**Calvert Cliffs
Nuclear Power Plant**

SUBJECT: Calvert Cliffs Nuclear Power Plant
Unit Nos. 1 & 2; Docket Nos. 50-317 & 50-318
License Amendment Request: Safety Injection Tank Verification Frequency

Attachments: (1) Analysis
(2) Determination of Significant Hazards
(3) Technical Specification Marked-up Page

FIGURE 1

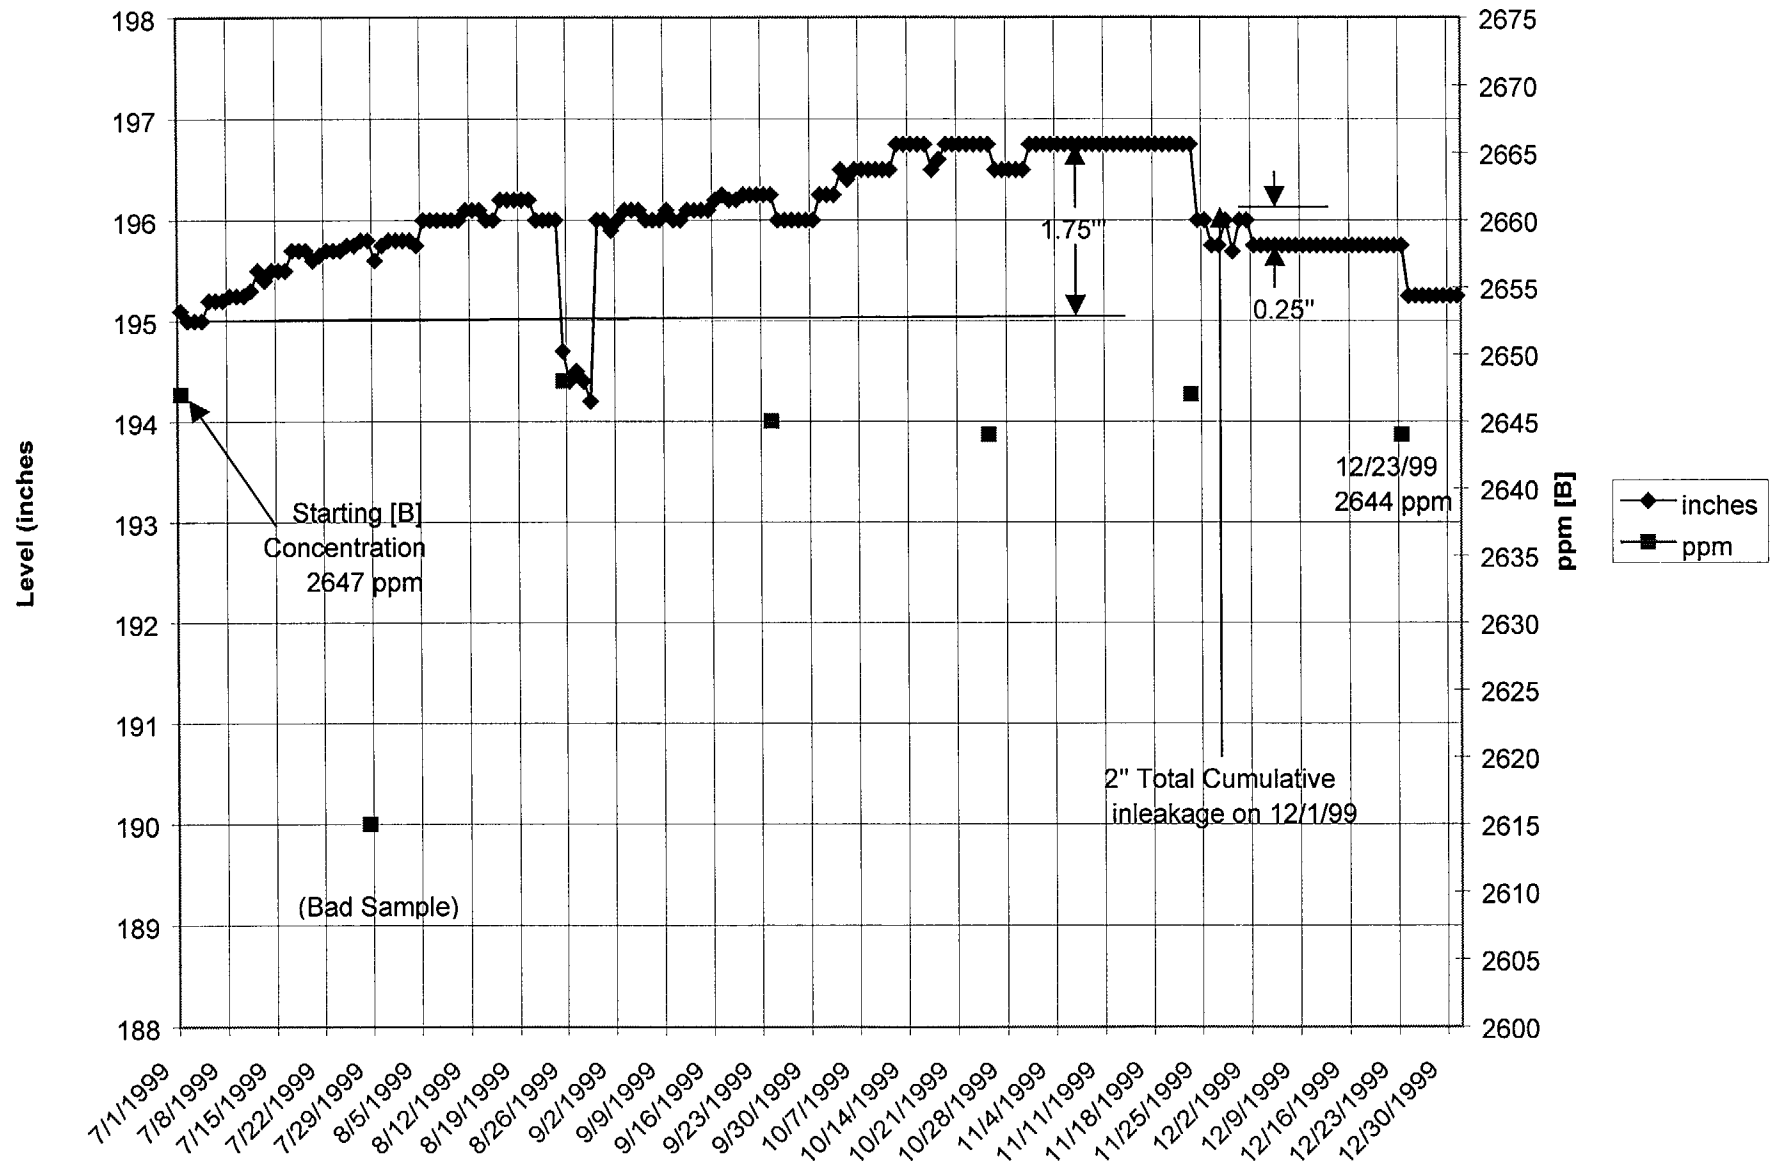
If we trend increases in SIT level then it is important to have the ability to differentiate between inleakage and level replenishment. This is made easier when the SIT levels are trended and graphed over time. Inleakage shows up as a gradual increase and SIT additions show up as a step change. Examples are given in Figures 1 and 2.
